DAMMON ENGINEERING INC
 Date: 10-9-15 Project: TEXTRON
 Reviewed: _____
 Reviewed as Noted: _____
 Revise and Resubmit: _____
 Rejected: _____
 Other: _____

Submital Item: FIRE ALARM
 Comments: _____

TEXTRON - STONE ROAD ADDITIONS
 252 STONE ROAD
 SLIDELL, LA 70460

SHEET TITLE	
FIRE ALARM SYSTEM	
DESIGNED BY:	M. LEJEUNE, JR.
DRAWN BY:	T. NEAL
APPROVED BY:	M. LEJEUNE, JR.
DATE:	JUNE 2015
SCALE:	1/8" = 1'-0"
PROJECT NO.:	881-11
DRAWING NO.:	FA-1.0

FLOORPLAN
 1/8" = 1'-0"

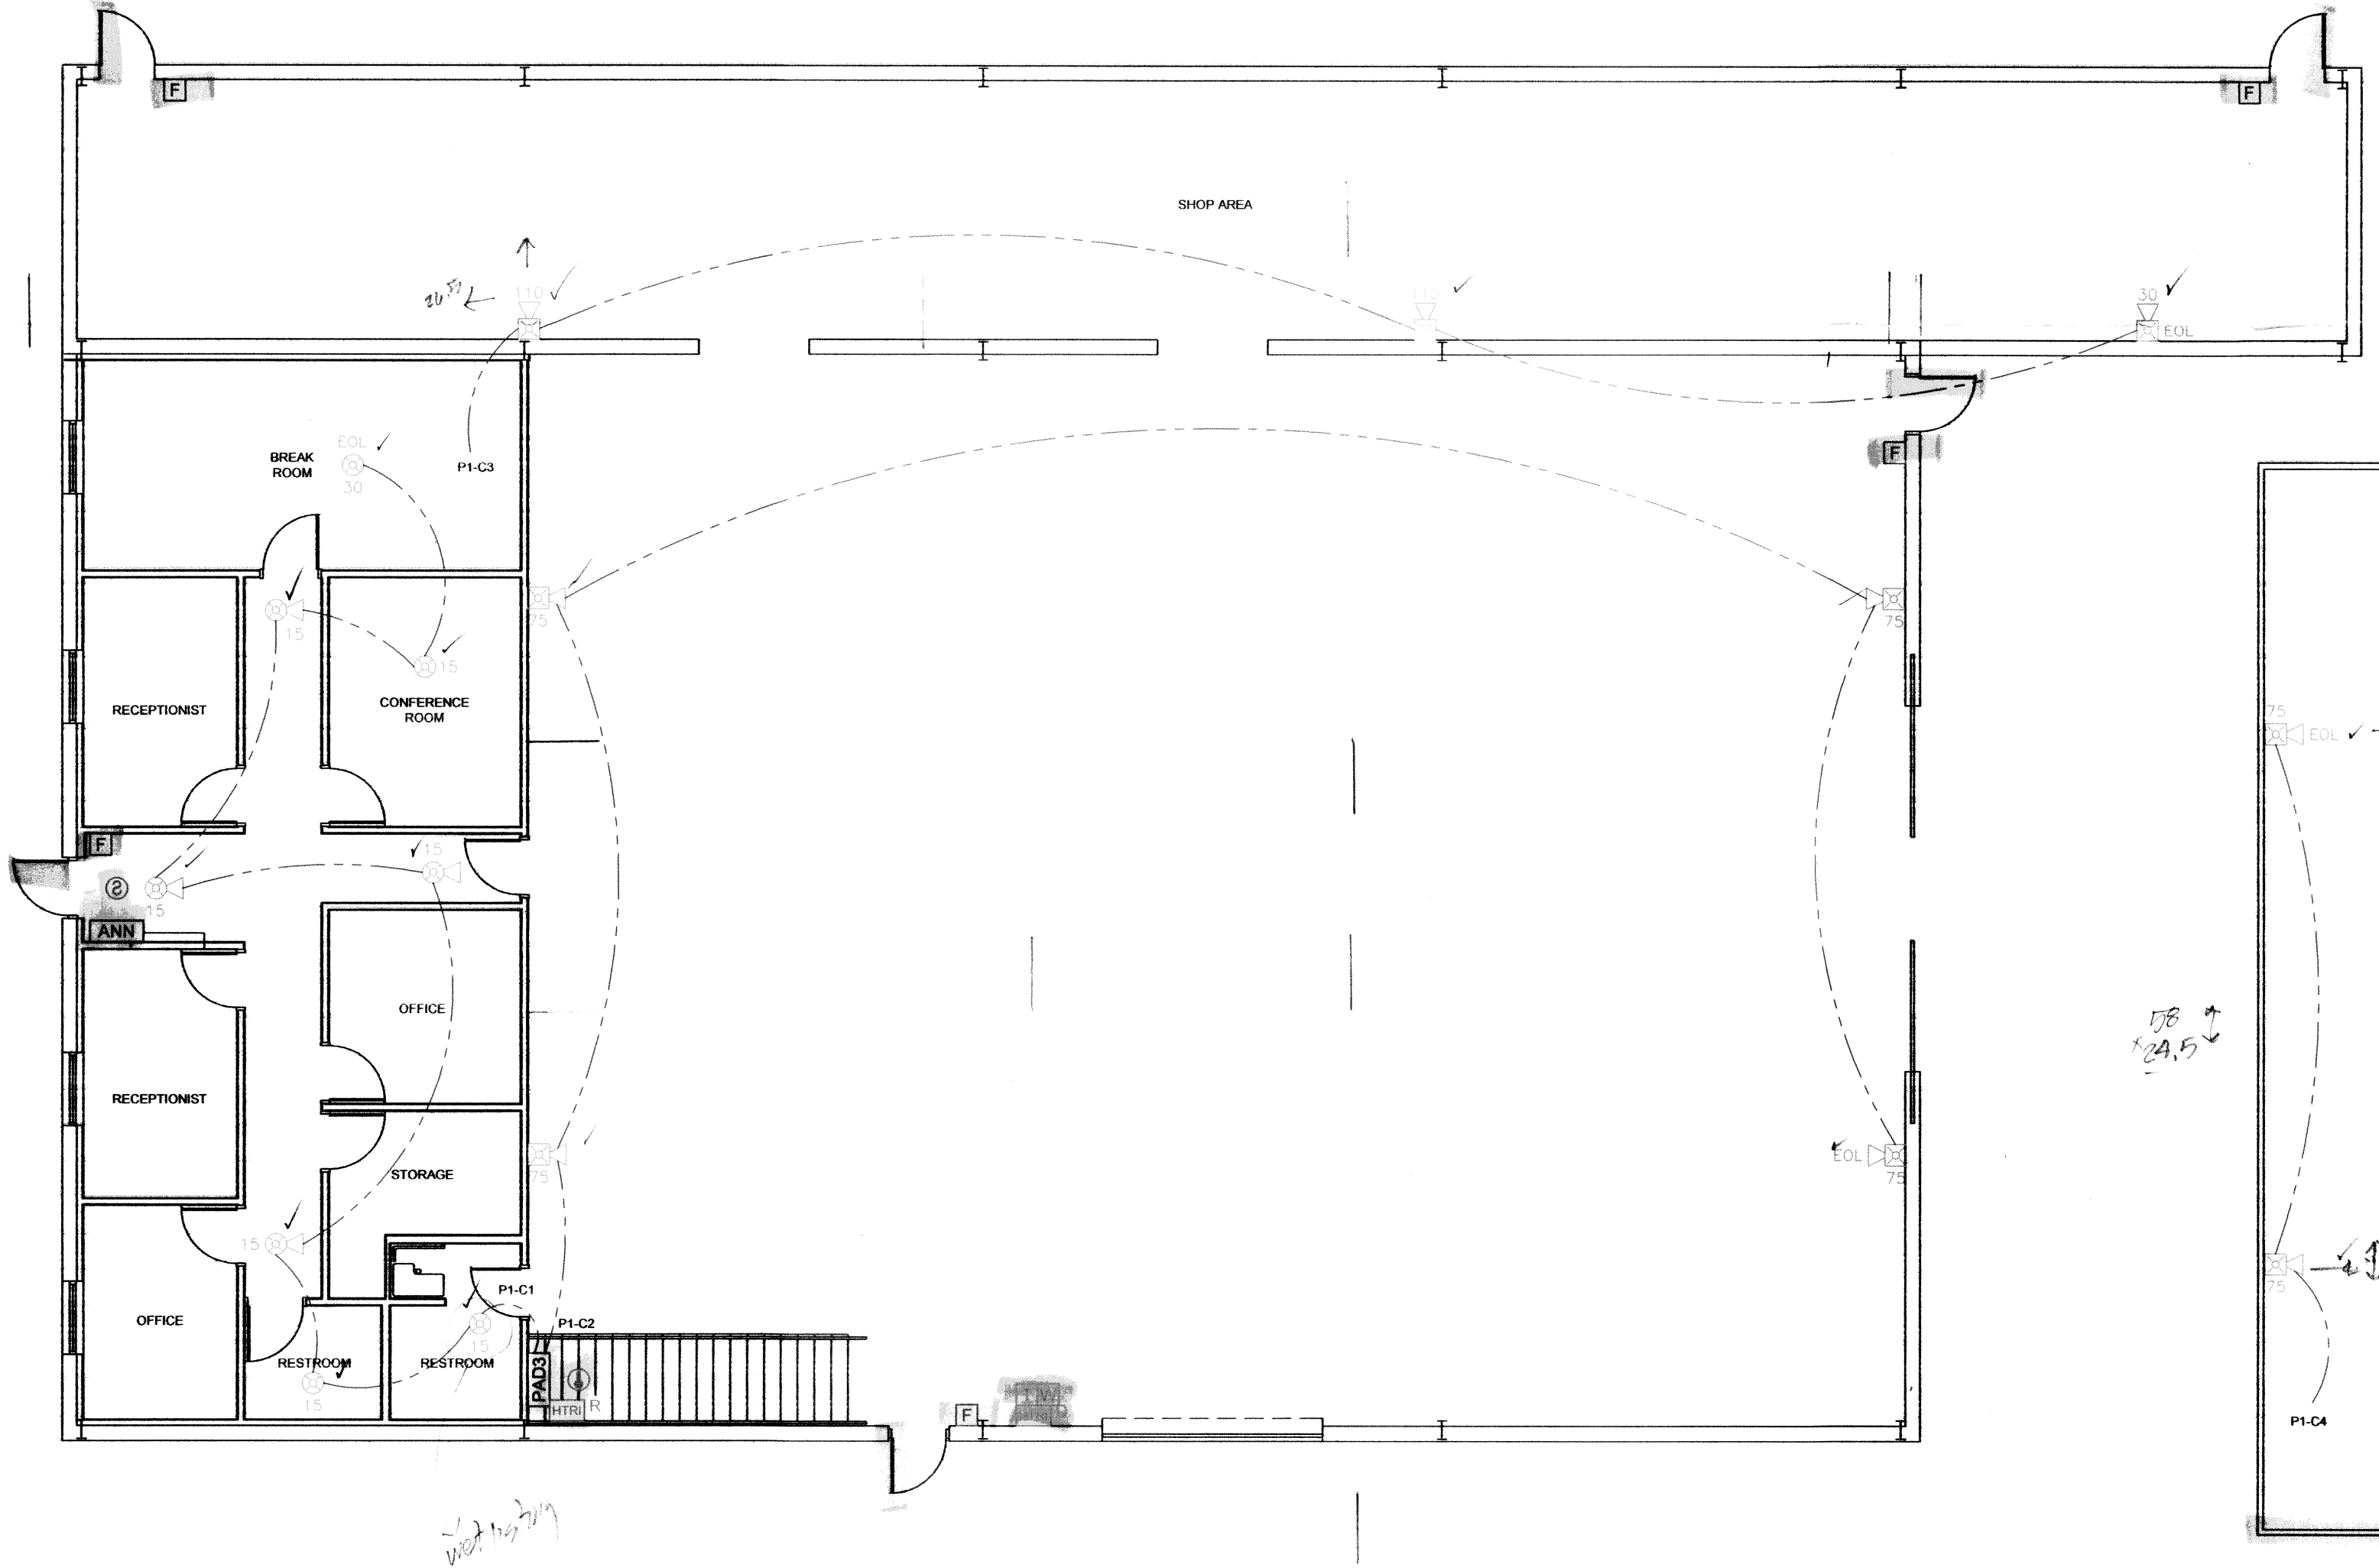
CPT 250' 75" (100' if sprinklered)
 it is -> P1-C1/2/3/4
